UNITED STATES
NUCLEAR REGULATORY COMMISSION

SUBJECT: MOV TERMINAL VOLTAGE ISSUE PER GL 89-10 PROGRAM AT
SEQUOYAH NUCLEAR PLANT

**JUSTIFICATION OF OPERATING VOLTAGES USED IN GL89-10
EVALUATIONS**

VOLTAGE PROFILE FOR SI-PH B

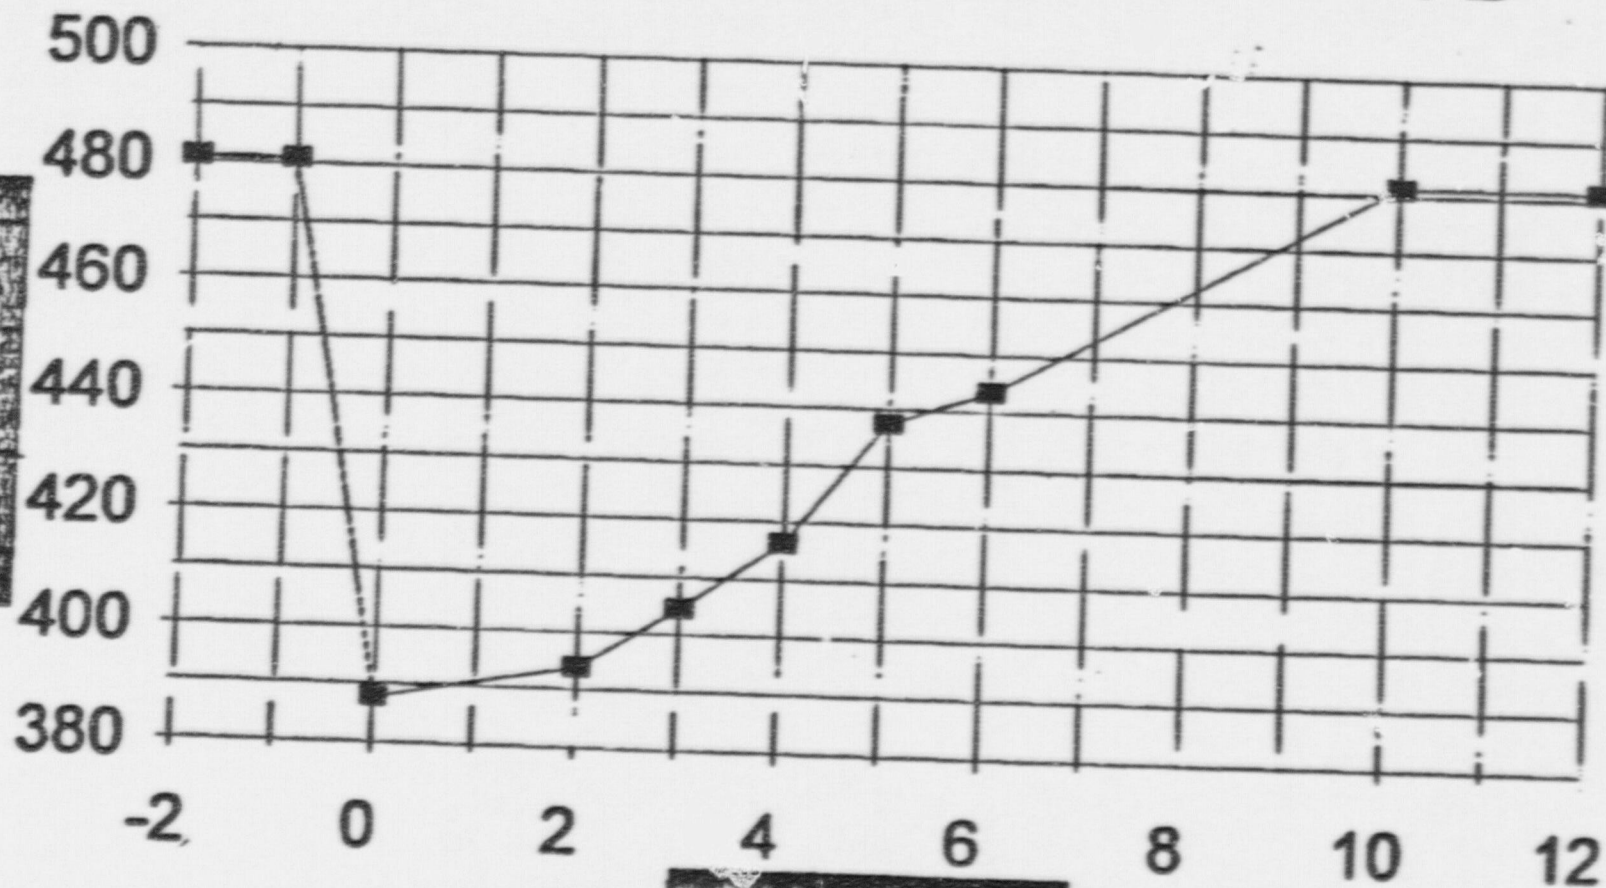
If a MOV is required to operate in automatic mode at onset of an design basis event, the MOV terminal voltage is evaluated to ensure that adequate voltage is available when the MOV is required to operate after the SI phase A or B signal. During this time period the 161kv offsite power supply is conservatively assumed to instantaneously drop from its normal operating voltage of 165 ± 1kv to 153kv (due to postulated worst case transmission system contingency) in conjunction with the block starting of all safety-related loads actuated by the SI phase A or B signal. As a result the 6.9kv Shutdown Board voltage will drop to below the degraded voltage setpoint of 6456 volts to approximately 5850 volts. The automatic load tap changers (LTC) on the Common Station Service Transformers (CSST) will start, after a 2 second time delay, boosting the voltage approximately 1.25% each second until the voltage recovers to within the LTC voltage range of 6997-7107 volts. The voltage will recover sufficiently to reset the degraded voltage relay (6595 volts) within 6 seconds.

We conclude that the licensee's approach for determining the operating voltage for its safety-related MOVs is acceptable.
